Report to the Manitowoc Plan Commission

Request: PC 3-2023: EastPoint Land Development / Howe; Review of Subdivision Preliminary Plat for The Preserves at Lincoln Park Parcel # 817-304-010.

PRELIMINARY PLAT

**Mike Howe
PC 3-2023
1/25/2023**

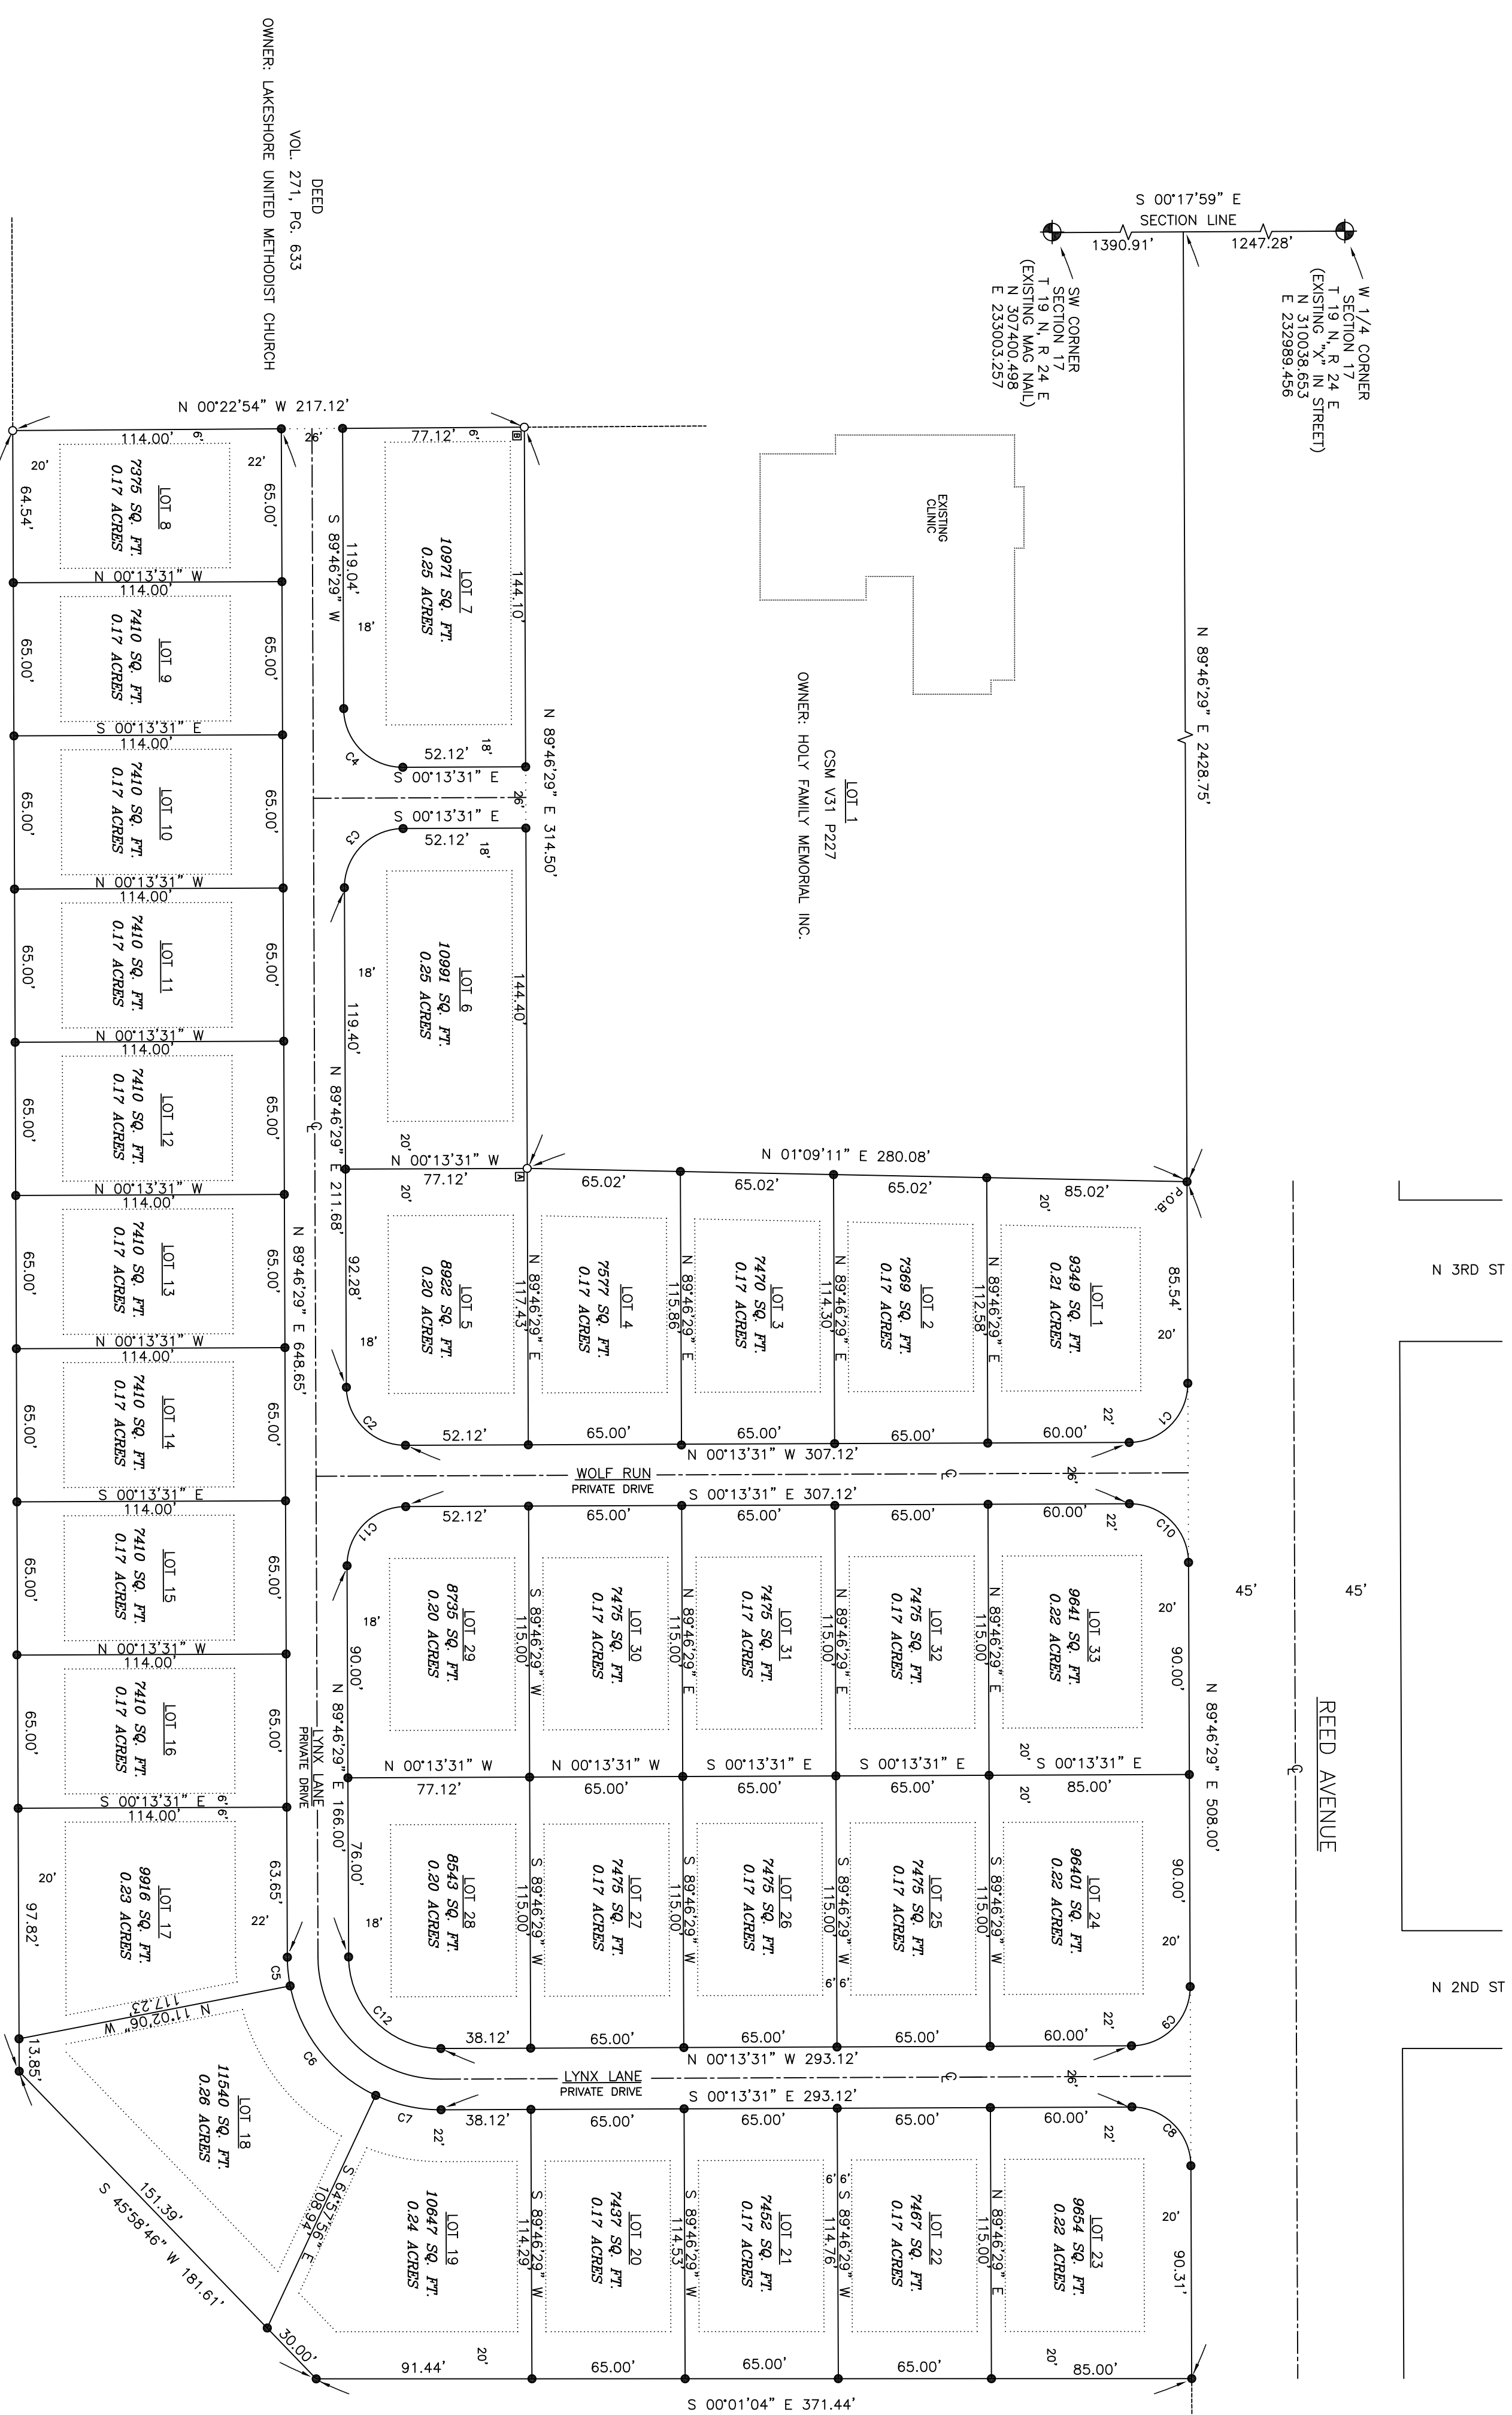
- d. The City will require a plan of the stormwater pond at a scale of 1-inch equals 20 feet as well as detailed cross sections. A clay liner is recommended as the pond needs to hold water at the permanent pool level. Cut off walls are also recommended to prevent water from moving through the stone bedding around the outfall storm pipe. The outfall pipe shall be connected to the City's storm sewer at Reed Ave. As part of the Reed Ave. reconstruction project, the City will upsize the existing inlet lead to accommodate the stormwater pond discharge. It cannot be discharged to flow over the gravel parking lot to the east. Is there a plan sheet that shows the outfall structure details and the trash rack details?

- j. All pipe material on City property and within all Right-of-Ways shall be PVC or RCP. Please indicate the pipe sizes on the plan for city to review.

- l. Winter Stabilization shall be required for all disturbed areas within 14 calendar days.
- m. The new sanitary sewer crossing Reed Ave. from Wolf Run shall be installed closer to a 90-degree angle. This will require a new manhole to be installed over the existing 10-inch sanitary sewer on the north side of Reed Ave. The location of the sanitary sewer as shown on the current plan is not acceptable. As a result of the realignment, the proposed sanitary manhole at the ROW line of Wolf Run could be eliminated. Therefore, there would be 270 feet of 8-inch pipe in lieu of 200 feet.

- q. The City intends to bulkhead the existing inactive sanitary laterals and main stubs that serve the property during the Reed Ave reconstruction work. The pipes being bulkheaded are currently not in use and extend south of Sanitary manholes 17-34A, 17-33A and 17-34.

- r. The existing and new sanitary manholes shall be labeled on the plans.
- s. Both of the new private roads (Wolf Run & Lynx Lane) shall have curb returns.

- t. The new private sanitary manholes shall be located outside of the new 10-foot-wide asphalt trail.
- u. The existing storm inlet at the northeast property line (location of the stormwater pond discharge) on Reed Ave. has the wrong elevations. The elevations shown are for the sanitary sewer and not the storm sewer inlet.

- c. The plat shall be in conformance with the Planned Unit Development for The Preserve at Lincoln Park.
- d. Block labels shall be shown on the plat.
- e. All existing and proposed easements shall be shown on the plat. Easements intended to be no longer used shall be released by the Plan Commission and Common Council with the proper release of easement documents being recorded at the Register of Deeds Office.

- f. Add a note on the plat stating that a Planned Unit Development district overlays the property. Include recording information in the note.
- g. Correct the location of N. 3rd and N. 2nd Streets on the plat, they are not shown accurately.

- h. Correct Mayor Nickel's and Mackenzie Reed's signature lines.
- j. Clarify in the legend what the dotted line work represents in each lot.
- k. Label the access drives as OUTLOT.

- b. *Profiles & Extensions:* Not shown...will need a profile drawing of the watermain design. Contact Rob Michaelson at 920-686-4354
- c. MPU Water will need to see the detailed watermain plan and profile drawings for the watermain installation.

- f. AT&T. Please provide a 12' utility easement to allow AT&T to place fiber optic cable to serve addresses. AT&T intends to place in same trench as MPU to service lots. Contact Kari Jensen for more details 920-227-8902 cell, 920-433-4112 office.

- g. WPS. A 12' utility easement reviewed by the WPS Real Estate Dept would be necessary to install natural gas facilities through the proposed development. Developer can contact our call center (877-444-0888, Monday – Friday: 8 a.m. – 5 p.m.) to apply for gas facility extension

- a. Place a 10' utility easement along south side of Reed Ave on the final plat. Location of utility easements along back/front lot lines of subdivision will need to be finalized. Please contact Manitowoc Public Utilities: Justin Hoffmann at (920)686-4347.
- b. Show access easement for the stormwater pond along lots 23, 22, 21, 20, and 19.
- c. See easement requests in other sections of this list of conditions sheet.
- d. All stated conditions to be satisfied to City satisfaction prior to City signatures being affixed to the certifications on the final plat.

- a. Fire Rescue will want to see final plan for location and placement of hydrants. Fire Rescue assumes a private road would require placement of private hydrants.
